THIRD PARTY INSPECTION REPORT
FOR
CONSTRUCTION OF THIRD FLOOR
AT
SWARN JAYANTI HOSTEL BHAWAN

C.S.J.M. UNIVERSITY CAMPUS
KANPUR

INTRODUCTION:

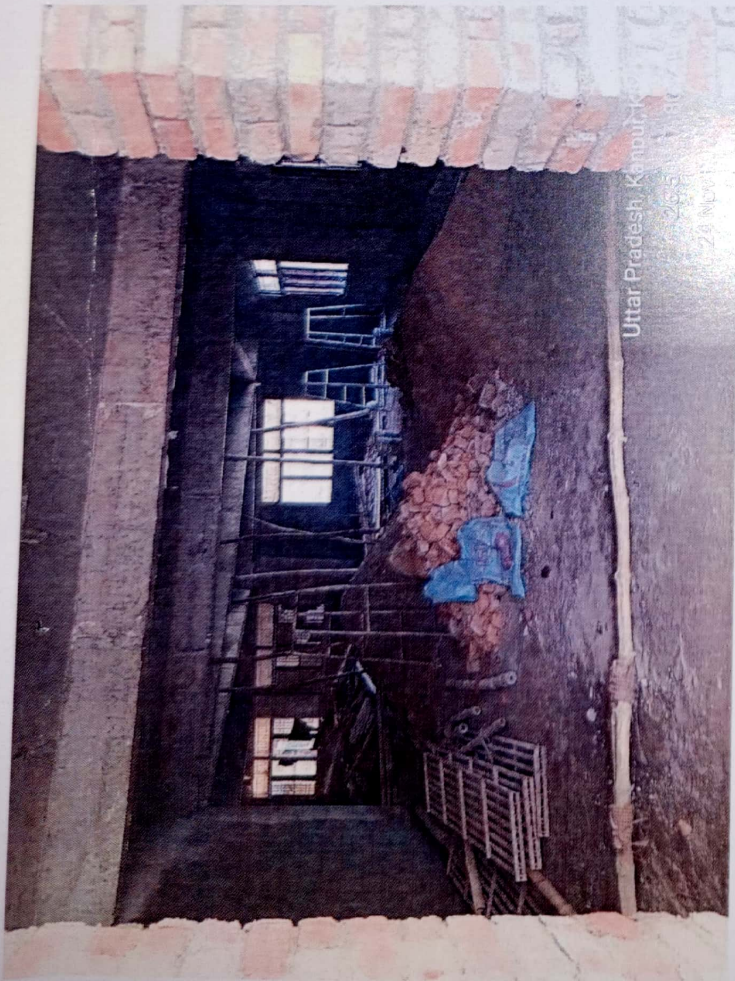
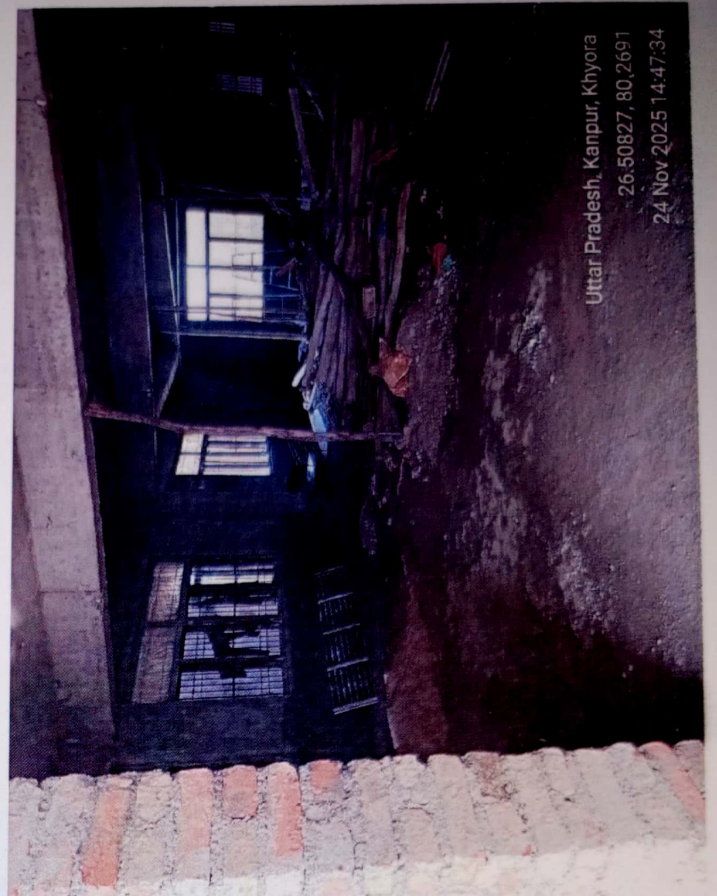
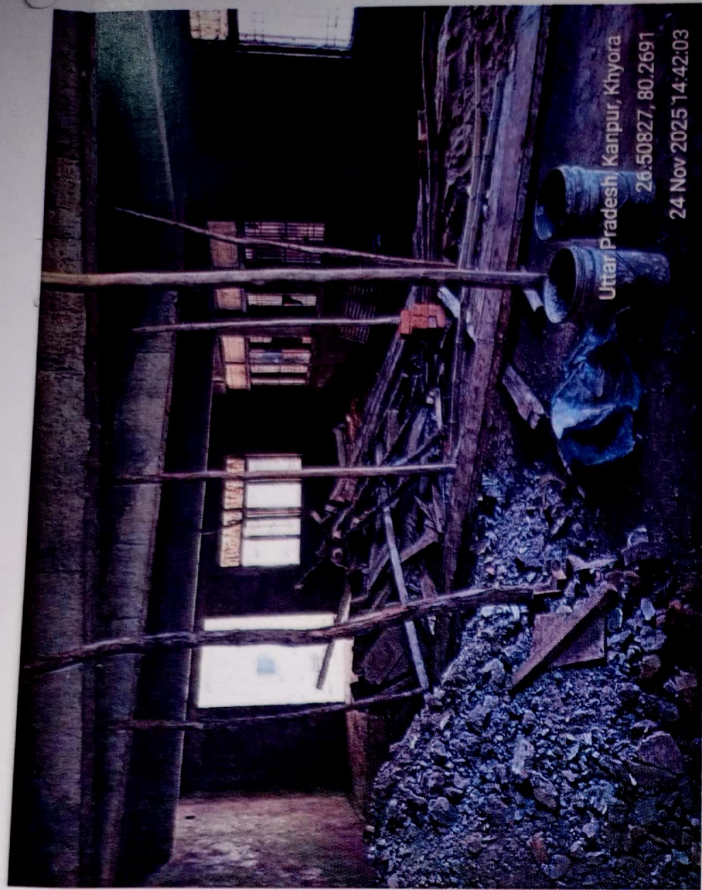
- Process and quality of rebar for columns.
- Construction of work as per approved plan and drawings.
- Proper use of structural steel as per approved drawings.

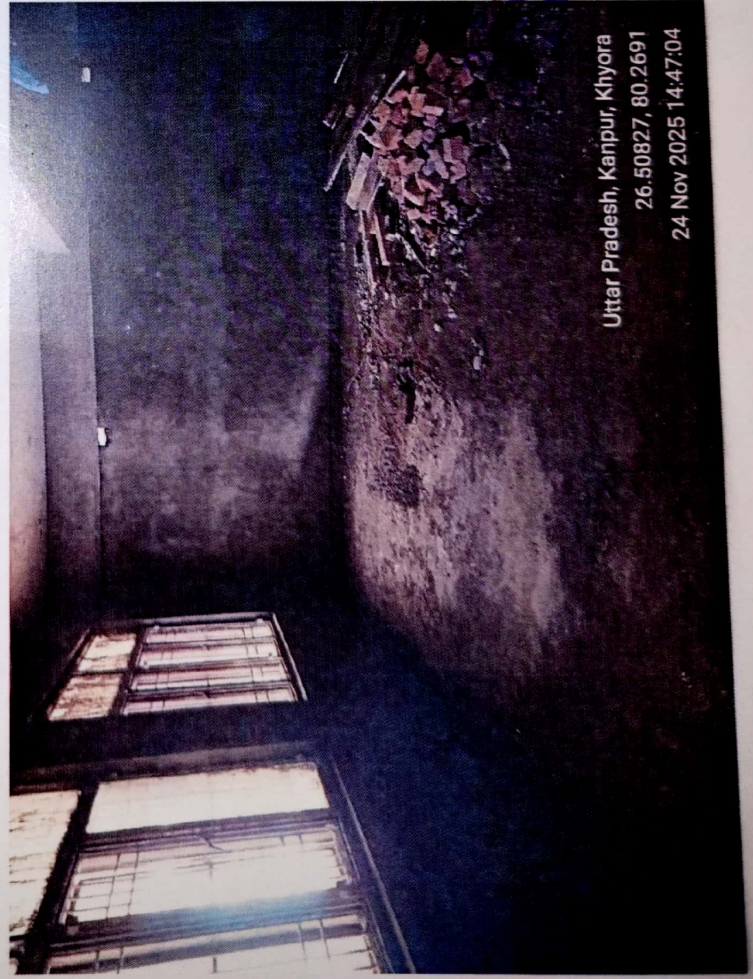
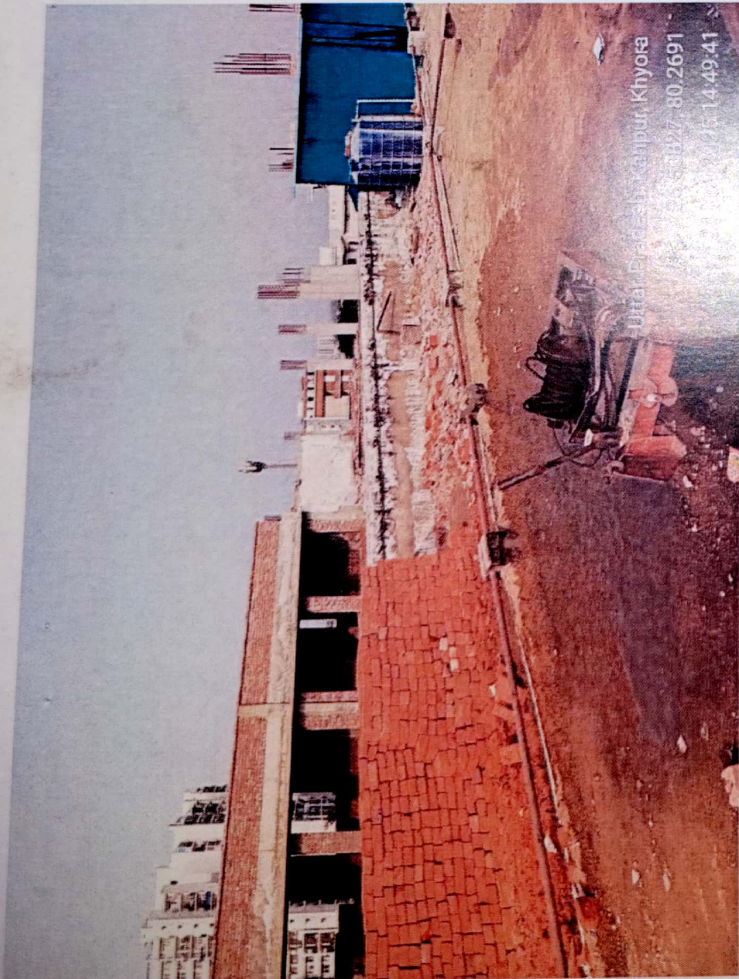
Reinforcement used for columns was found to be as per approved structural drawings. Proper overlaps were found in longitudinal reinforcement of columns. Bar bending site was inspected for rebarring of structural members and it was found satisfactory. Construction agency was asked to produce the design mix report for proposed mix of concrete. It was informed by the contractor and UPRNSS that they are using ready mix concrete even then they were instructed to get an approved design mix report of concrete and testing report of major concrete castings along with other relevant material testing reports.
